File: G23/0012
4500 Canyon Court NE
11/14/13 PE
Stamp.

COMMENT: DRAINAGE SWALE CALCULATION

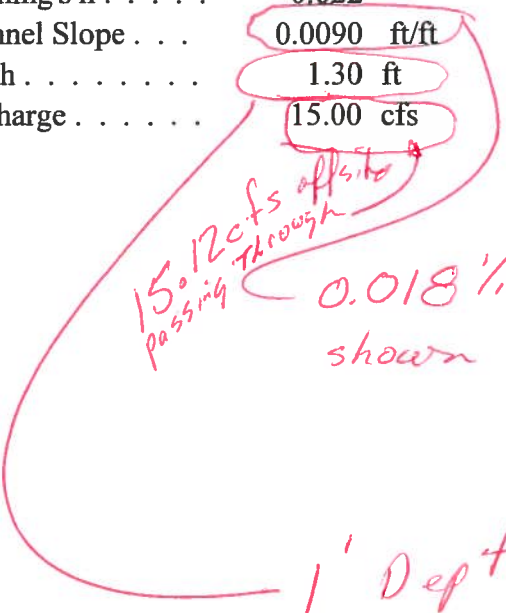
15.12 cfs passing through
0.018% min slope shown on plan

1' Depth shown on plan

Shown,
Please recalculate with
correct channel slope to
confirm that it will
contain the 15.12 cfs.

Email revised ditch calcs
& I can approve G&D.
